RE: Petition No. 1226  
Towantic Switching Station and Line Modification Project

**ATTACHMENT F**  
**REVISED PETITION MAPSHEET 22**  
**INCORPORATING LIGHTING MODICATIONS**

**TOWANTIC SWITCHING STATION AND LINE PROJECT**

APRIL 1, 2016  
 REVISED: JANUARY 23, 2017  
 WATERBURY, MIDDLEBURY, & OXFORD, CT  
 PAGE 22 OF 26

## **Case Description for ASN 2016-ANE-2344-OE**

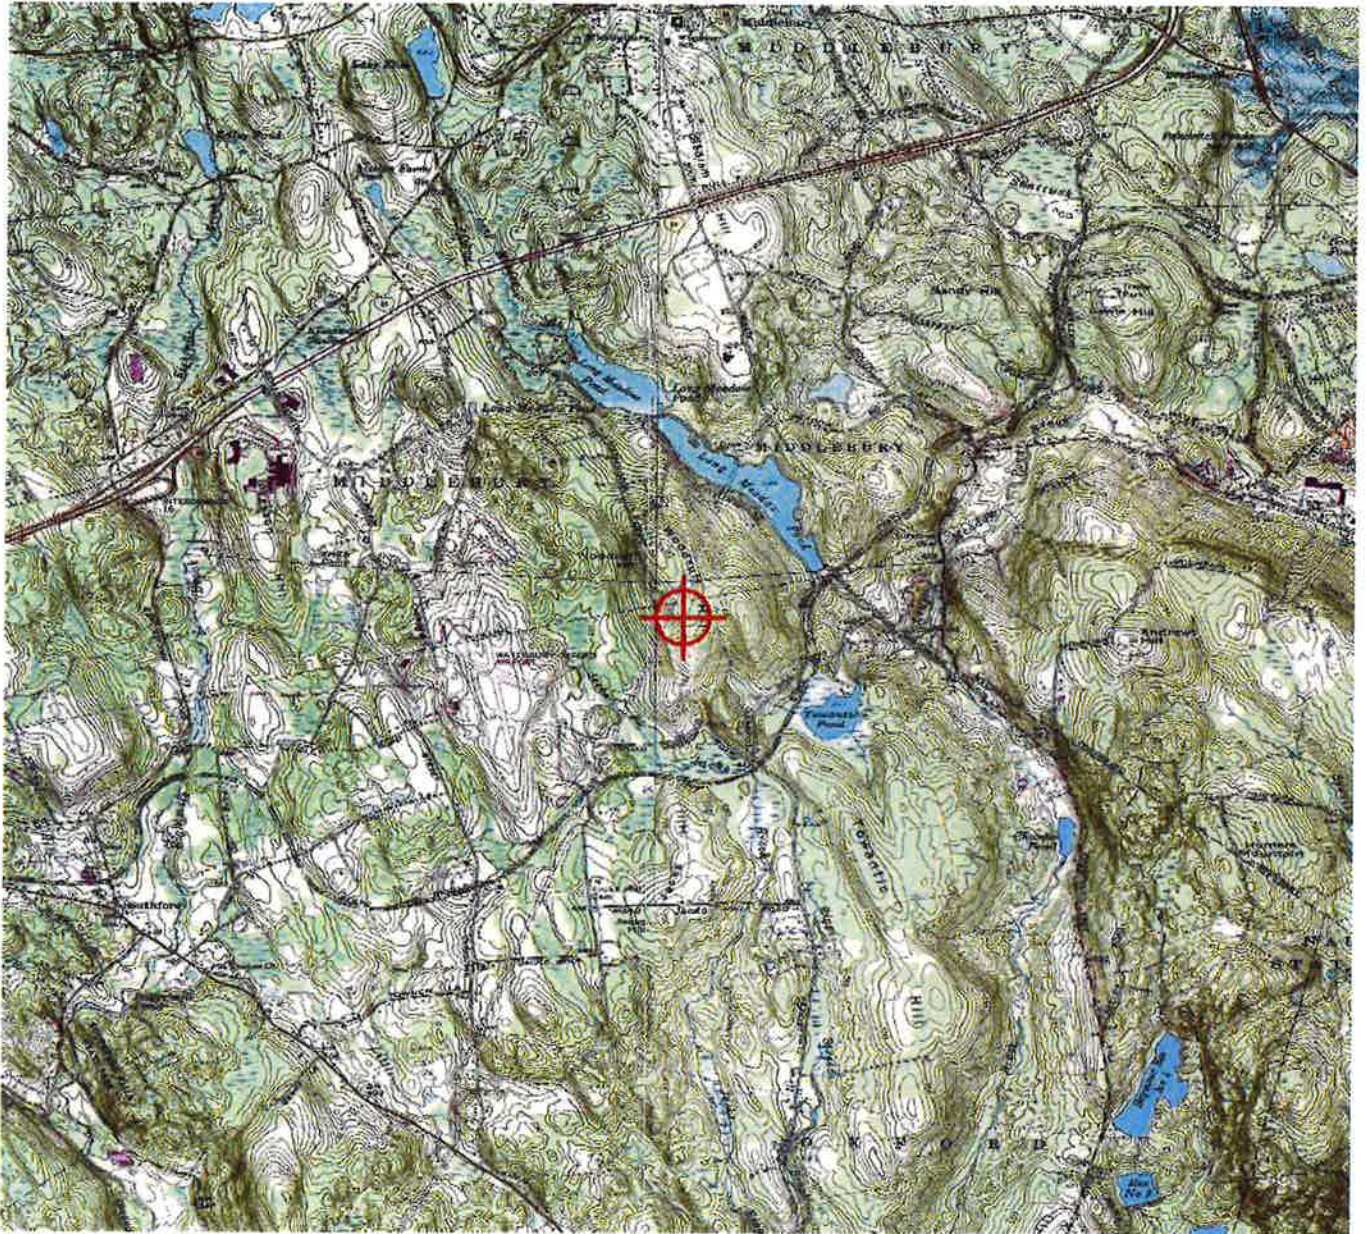
The proposed utility pole (A-Frame) supporting a 115-kV line, at a height of 81 feet (ft.) AGL / 911 ft. AMSL, would be located approximately 3,925 ft. east of the approach end Runway 18 at Waterbury- Oxford Airport (OXC), Waterbury, CT. The proposed structure has been identified as an obstruction under the standards of Title 14, Code of Federal Regulations (CFR), Part 77, as applied to OXC as follows:

Section 77.19 (a): A Horizontal plane 150 feet above the established airport elevation, the perimeter of which is constructed by swinging arcs of a specified radii from the center of each end of the primary surface of each runway of each airport and connecting the adjacent arcs by lines tangent to those arcs. The proposed structure exceeds the Horizontal Surface by up to 35 ft.

It is recommended the proposed structure be lit with a red light to make it more conspicuous to airmen should circumnavigation be necessary.

As a condition to this Determination, the structure is to be marked/lighted in accordance with FAA Advisory circular 70/7460-1 L Change 1, Obstruction Marking and Lighting, red lights - Chapters 4,5(Red),&12.

**Case Description for ASN 2016-ANE-2852-OE**

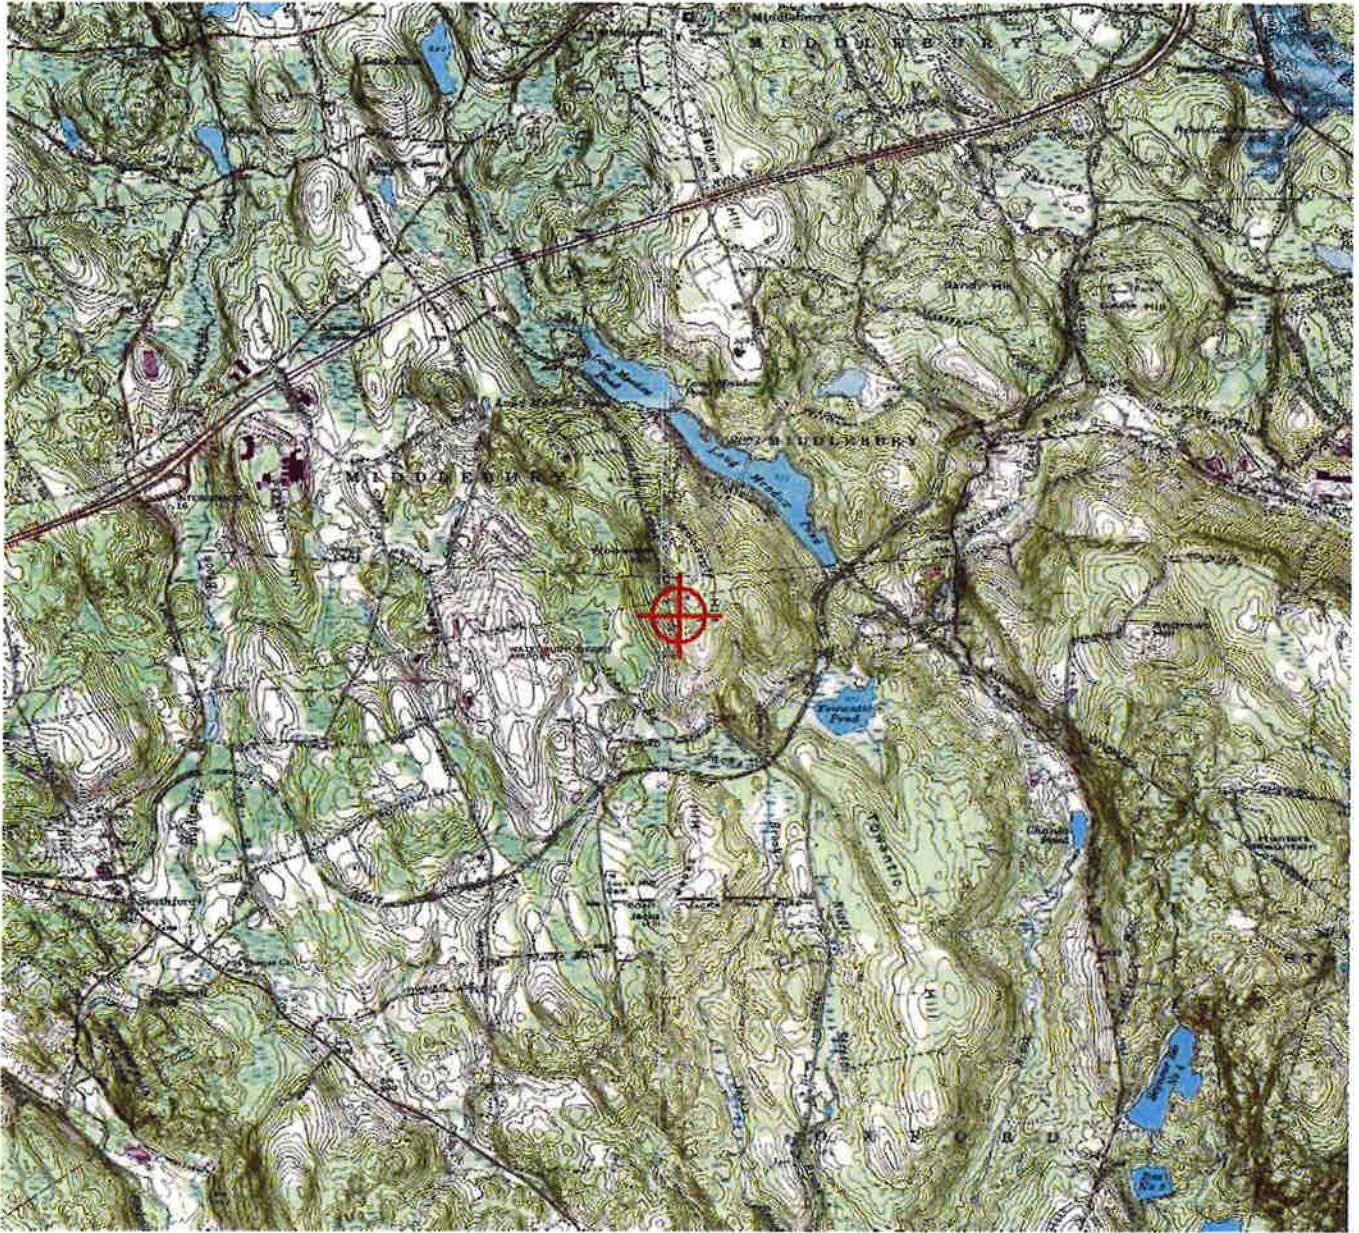
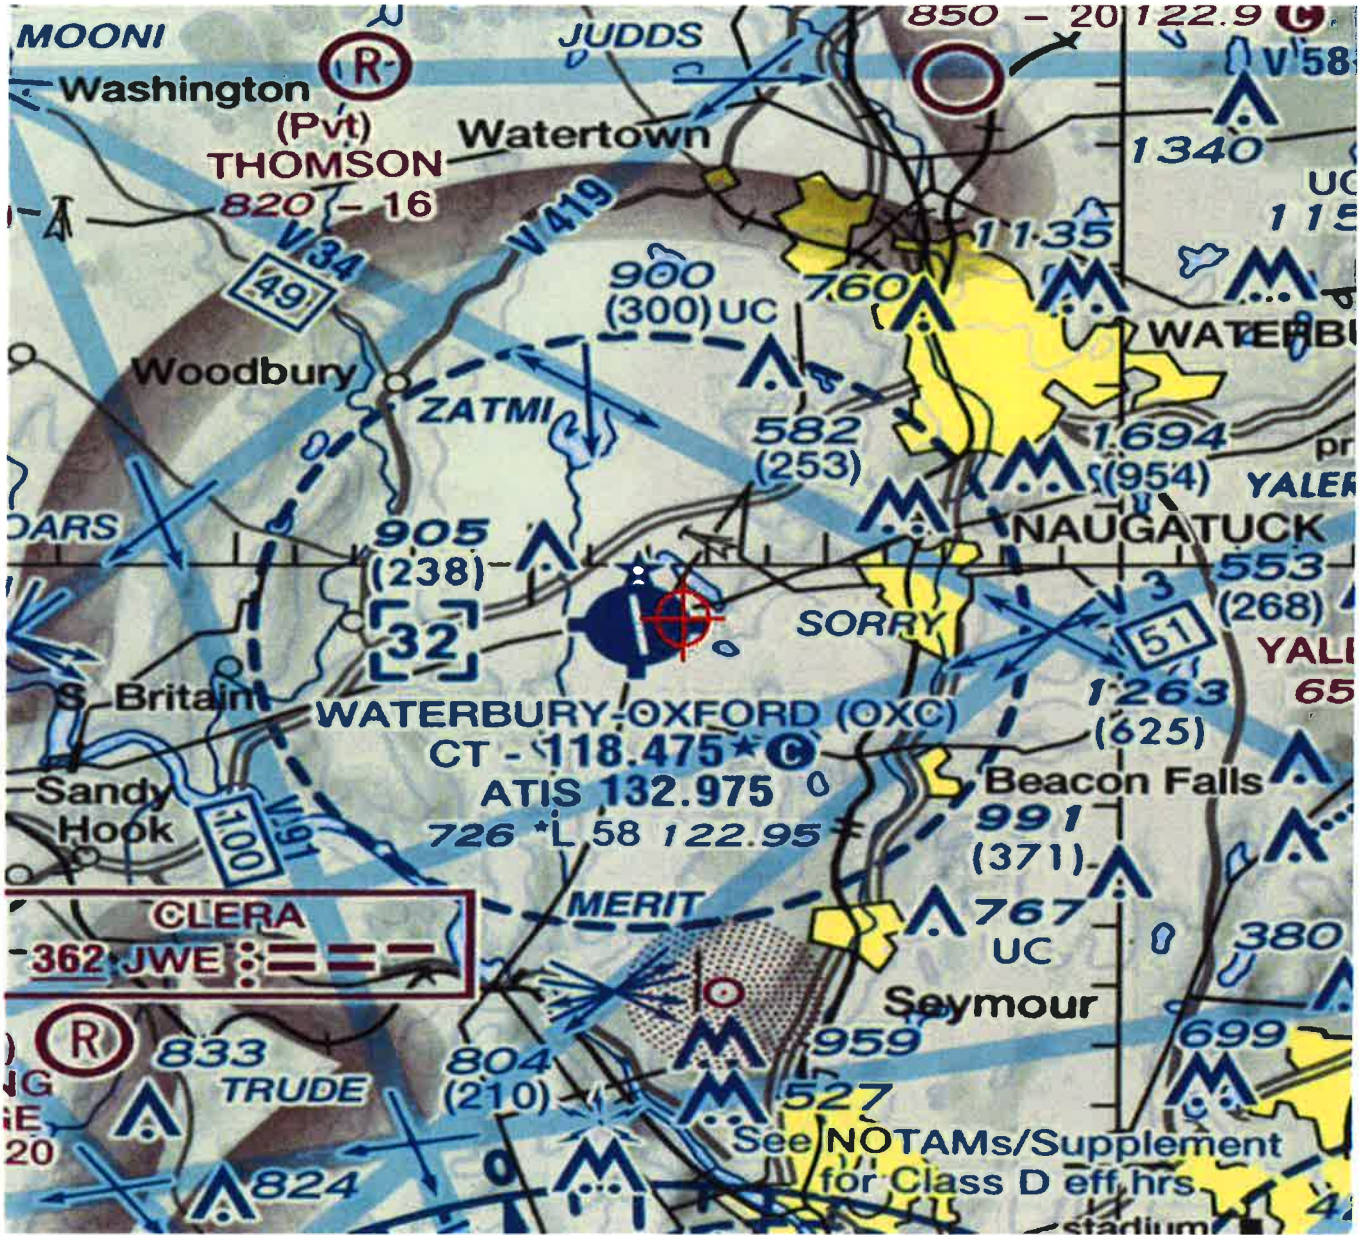
The proposed utility pole (11166-1990S) supporting a 115-kV line, at a height of 96 feet (ft.) AGL / 903 ft. AMSL, would be located approximately 3,630 ft. southeast of the approach end Runway 18 at Waterbury-Oxford Airport (OXC), Waterbury, CT. The proposed structure has been identified as an obstruction under the standards of Title 14, Code of Federal Regulations (CFR), Part 77, as applied to OXC as follows:

Section 77.19 (a): A Horizontal plane 150 feet above the established airport elevation, the perimeter of which is constructed by swinging arcs of a specified radii from the center of each end of the primary surface of each runway of each airport and connecting the adjacent arcs by lines tangent to those arcs. The proposed structure exceeds the Horizontal Surface by up to 27 ft.

It is recommended the proposed structure be lit with a red light to make it more conspicuous to airmen should circumnavigation be necessary.

As a condition to this Determination, the structure is to be marked/lighted in accordance with FAA Advisory circular 70/7460-1 L Change 1, Obstruction Marking and Lighting, red lights - Chapters 4,5(Red),&12.

**Case Description for ASN 2016-ANE-2853-OE**

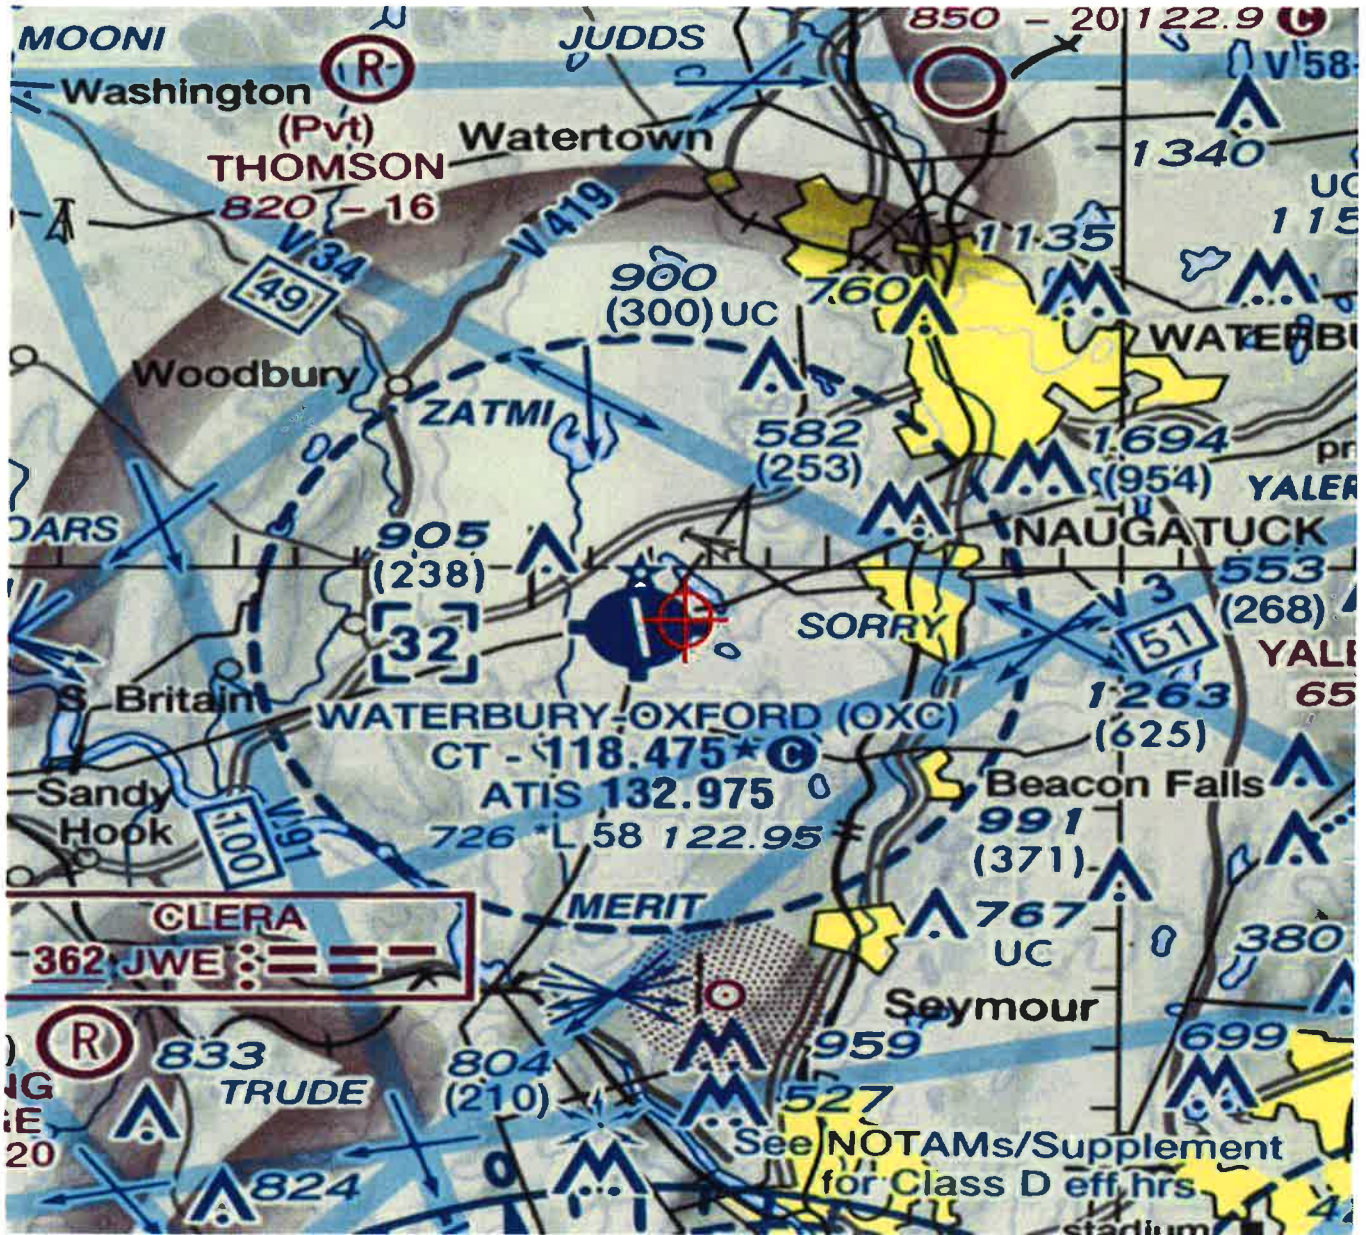
The proposed utility pole (11166A-1990N) supporting a 115-kV line, at a height of 96 feet (ft.) AGL / 926 ft. AMSL, would be located approximately 3,661 ft. southeast of the approach end Runway 18 at Waterbury-Oxford Airport (OXC), Waterbury, CT. The proposed structure has been identified as an obstruction under the standards of Title 14, Code of Federal Regulations (CFR), Part 77, as applied to OXC as follows:

Section 77.19 (a): A Horizontal plane 150 feet above the established airport elevation, the perimeter of which is constructed by swinging arcs of a specified radii from the center of each end of the primary surface of each runway of each airport and connecting the adjacent arcs by lines tangent to those arcs. The proposed structure exceeds the Horizontal Surface by up to 50 ft.

It is recommended the proposed structure be lit with a red light to make it more conspicuous to airmen should circumnavigation be necessary.

As a condition to this Determination, the structure is to be marked/lighted in accordance with FAA Advisory circular 70/7460-1 L Change 1, Obstruction Marking and Lighting, red lights - Chapters 4,5(Red),&12.

**DESIGN OF AVIATION WARNING LIGHTS ON**

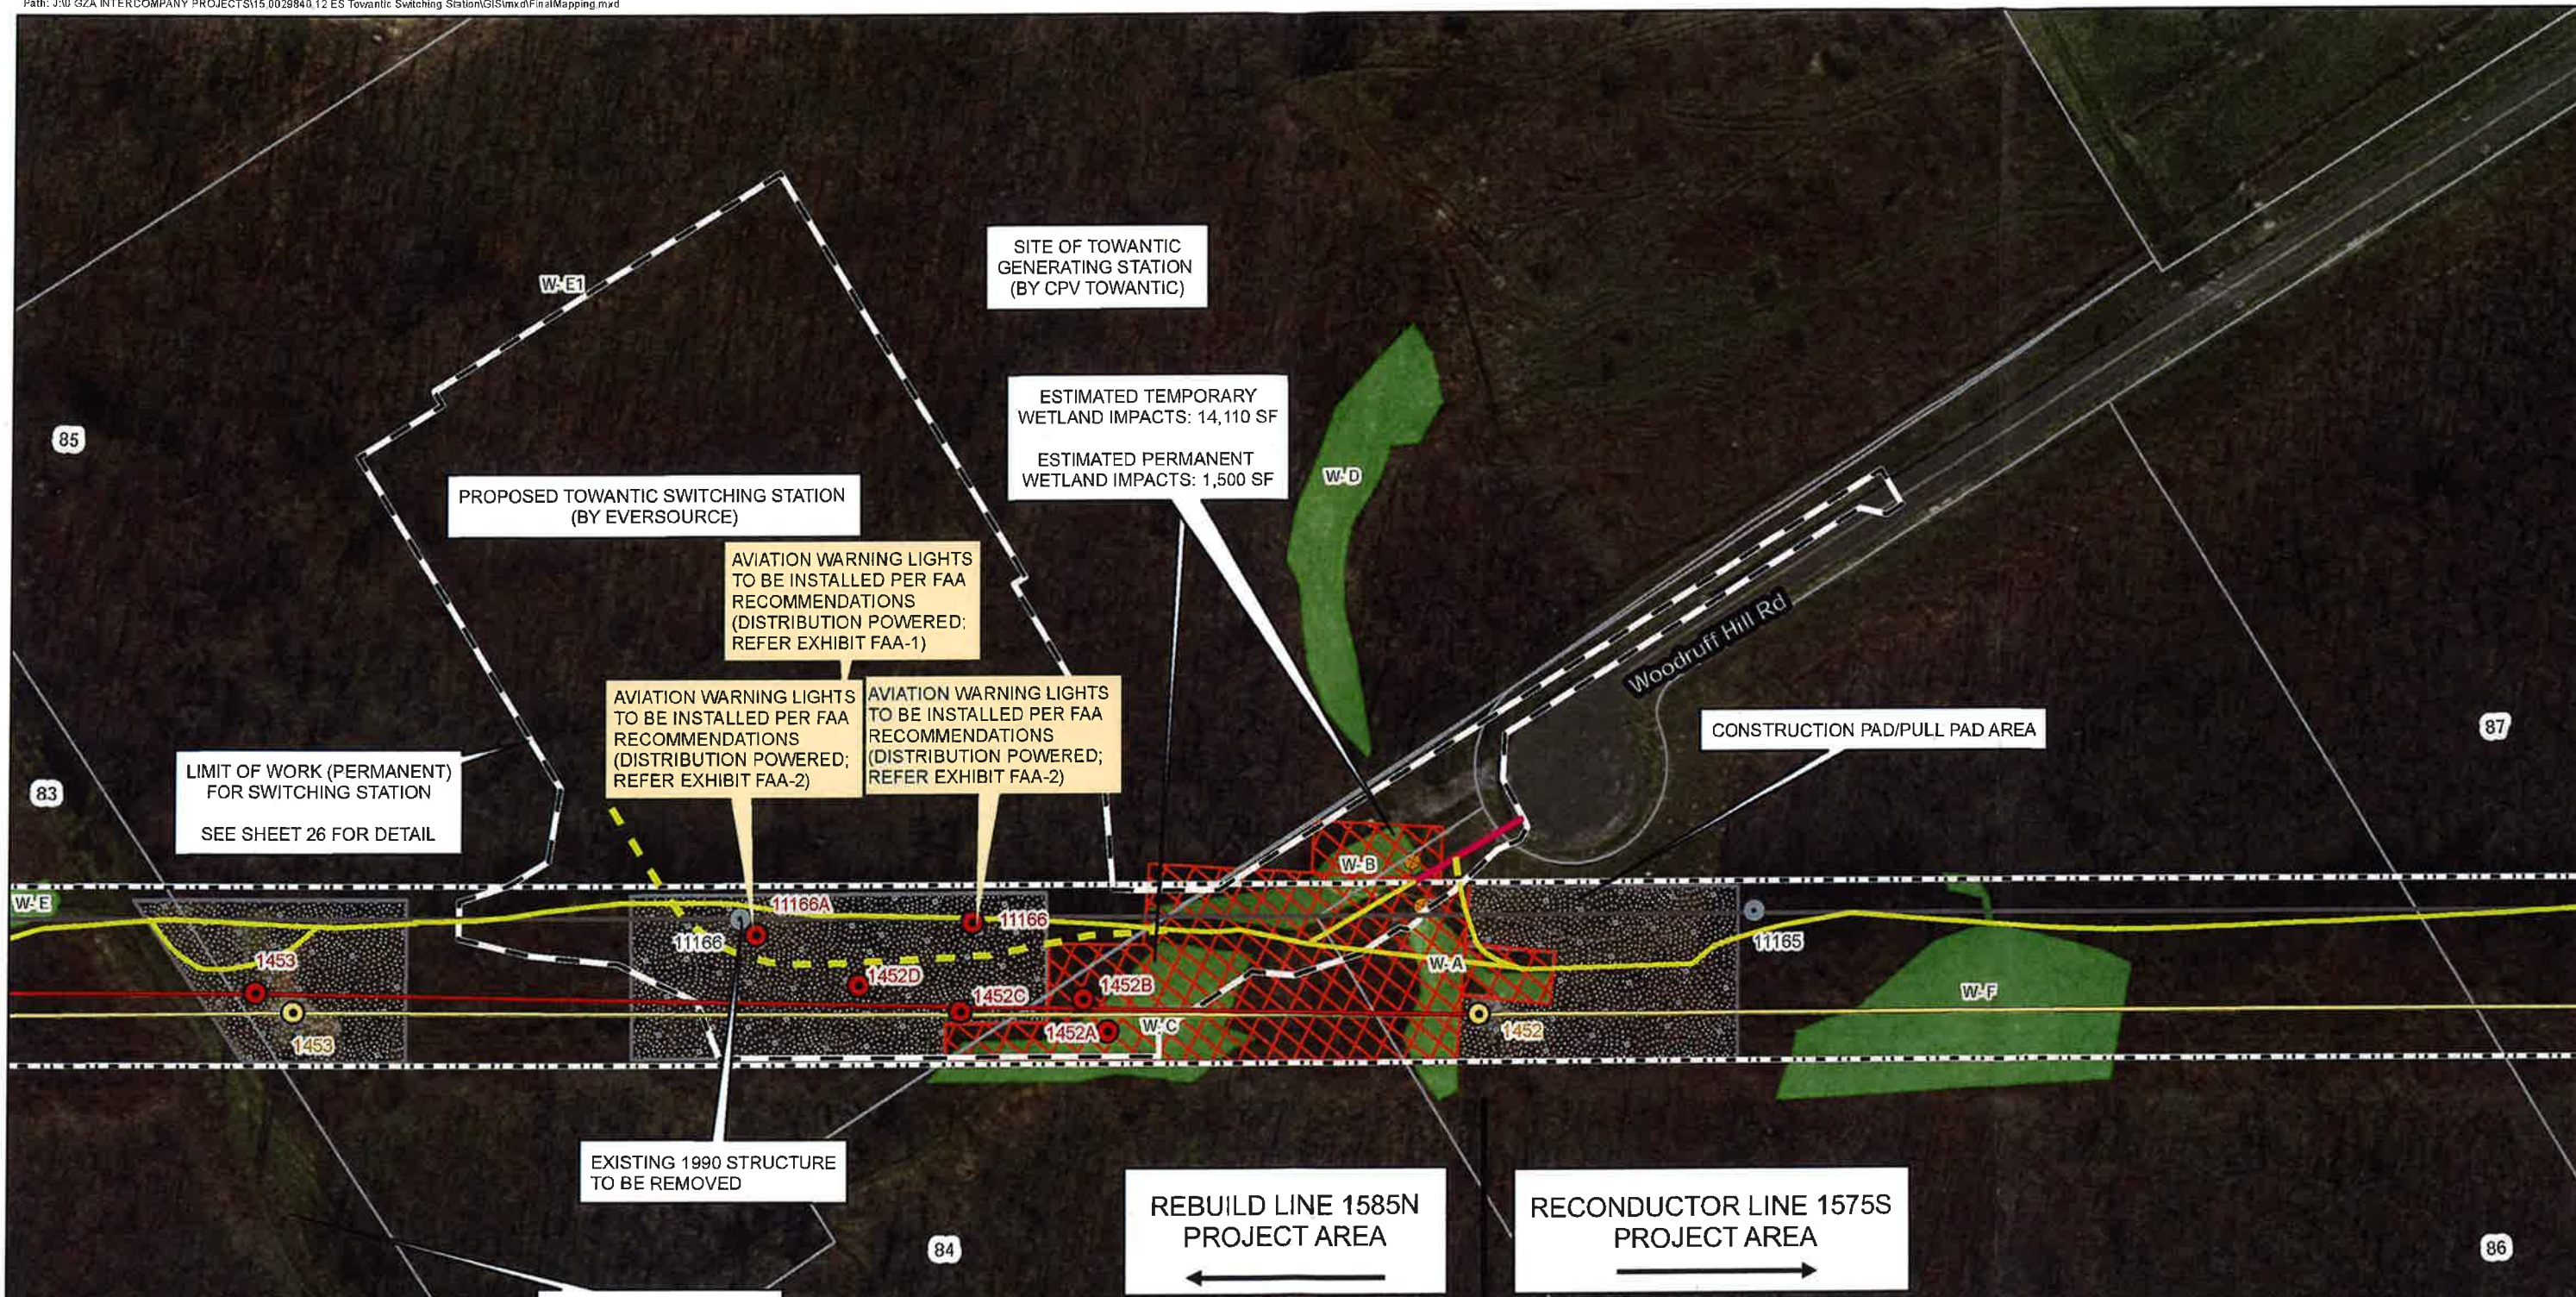
The three structures are located in the vicinity of the Oxford airport, in the Towns of Middlebury and Oxford. Eversource proposes to install steady-state red obstruction lights on two of the new transmission line structures, Structures 11166 and 11166A; and at two locations within the new Towantic Switching Station (“Station”). The Station was identified as “Utility Pole A Frame” since it is considered to be one major extensive obstruction (i.e., multiple obstructions at the same height located relatively close together including the lightning masts installed on A-frames, H-frames, and independent poles.)

The drawing provided in Attachment E illustrates the design of the aviation warnings on the transmission line structures and the proposed locations of the aviation warning lights on the Station structures.
